Regulatory Updates since the 3rd mission

Nuclear Regulation Authority JAPAN

16th Dec 2025

2. Review on TEPCO's REIA updated in Dec 2024

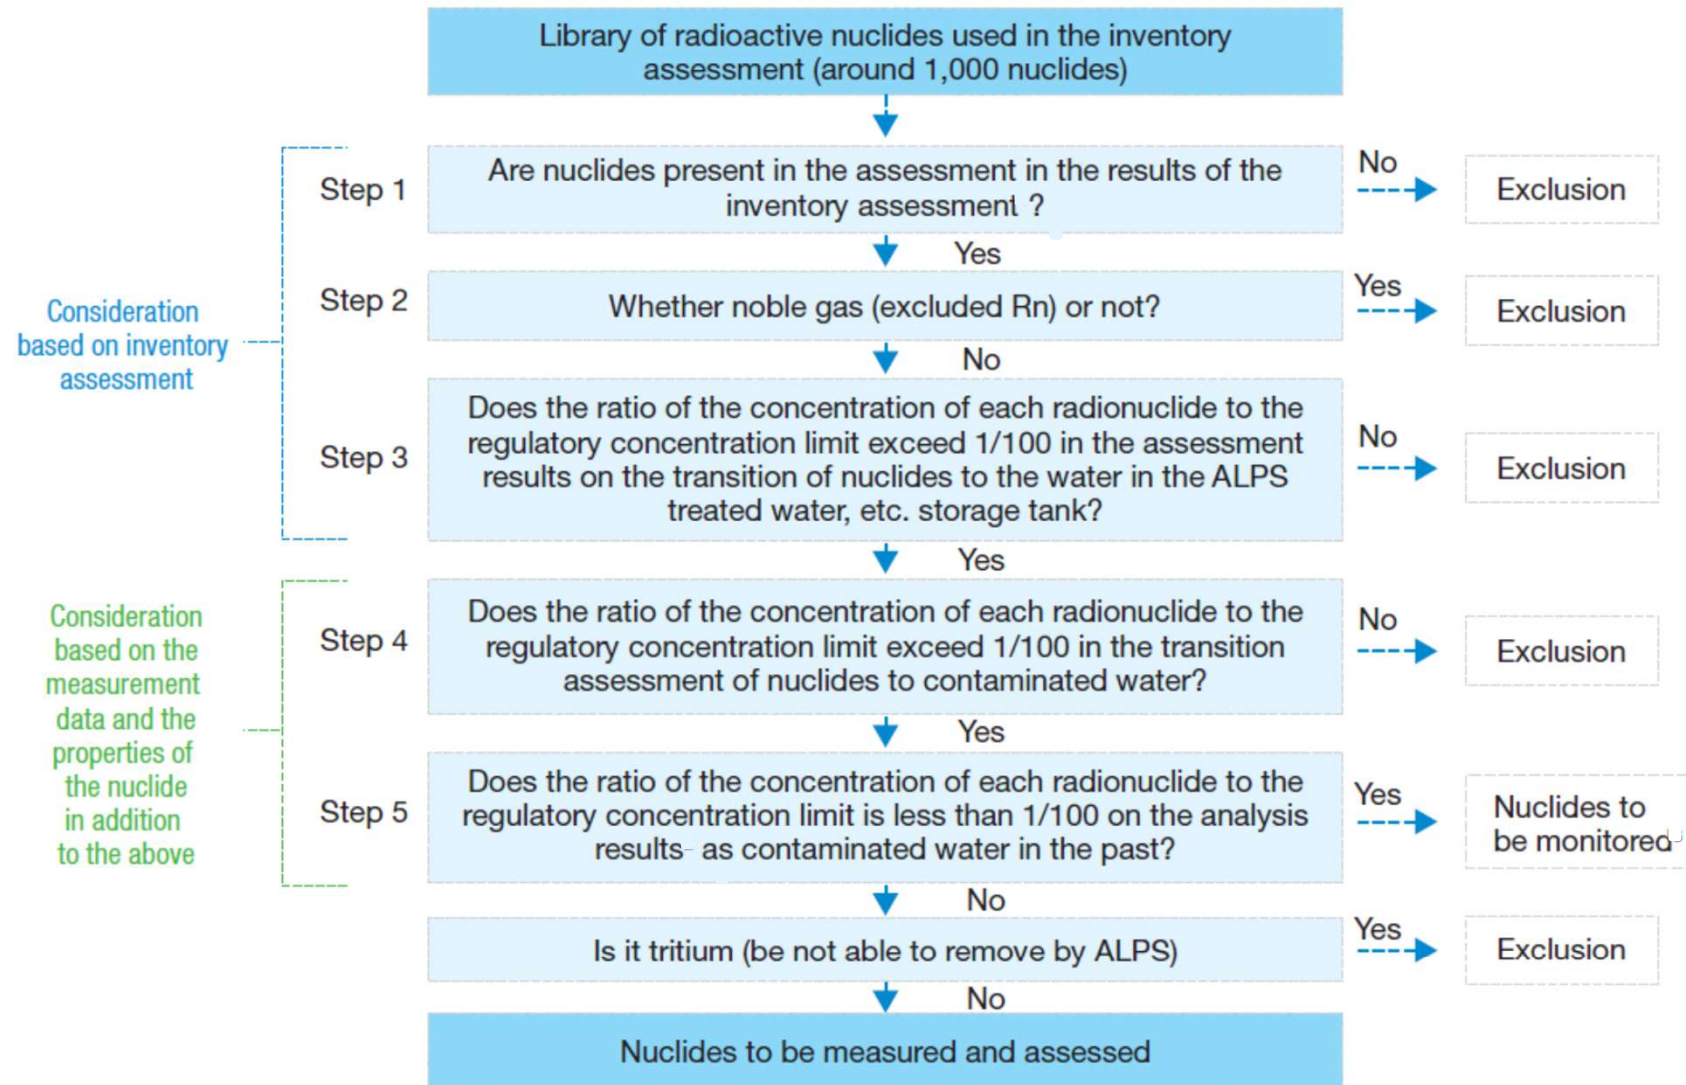
- NRA approved TEPCO’s flowchart to screen “Nuclides to be measured and assessed”, those are nuclides to be measured at every discharge of ALPS treated water.
- This year, TEPCO re-assessed the “Nuclides to be measured and assessed” based on the flowchart, and as a result, Ce-144 was excluded from “Nuclides to be measured and assessed” due to its short half life (285days).
- So far, Ce144 has not been detected in ALPS treated water since the 1st discharge.
- Therefore, NRA verified there was no safety concern on this update.
